# UNITED STATES PATENT AND TRADEMARK OFFICE

APPLICATION NO.	FILING DATE	FIRST NAMED INVENTOR	ATTORNEY DOCKET NO.	CONFIRMATION NO.
09/898,806	07/03/2001	Koki Kanda	0941.65658	5709

## Office Action Summary

## DETAILED ACTION

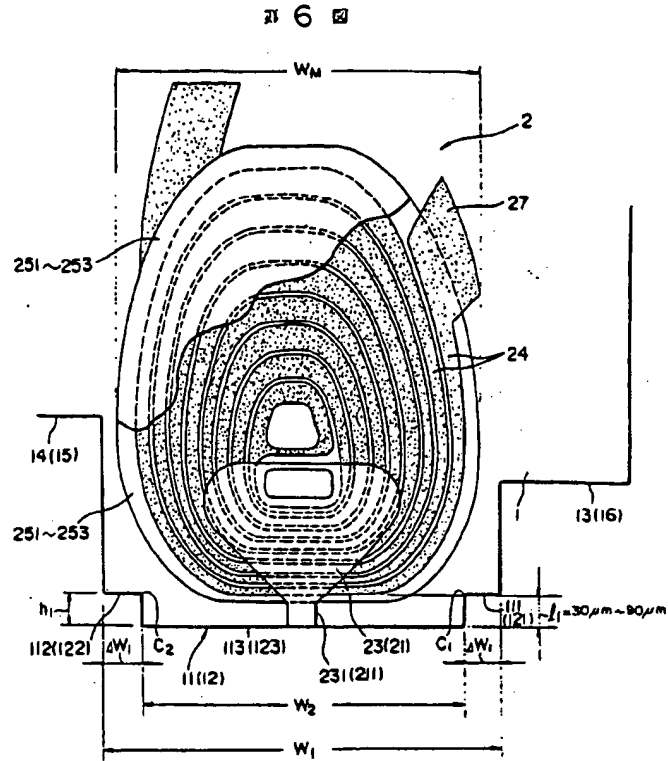
protective layer 3 is recessed away from corner intersection of the distal end of protective layer 3 and the ABS forming a ROUNDED recessed corner.

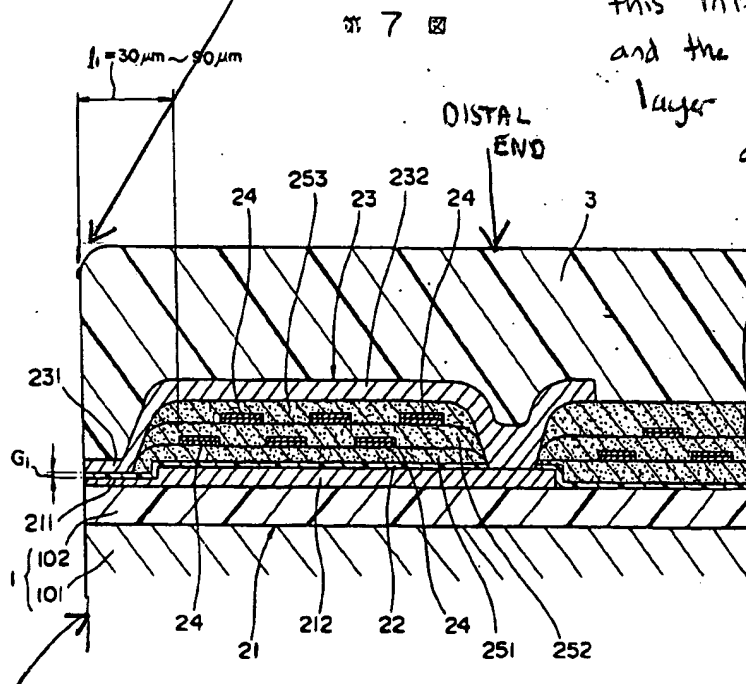
missing corner, hence curved surface at this intersection of layer 3 and the ABS. That is layer 3 is recessed away from a square corner.
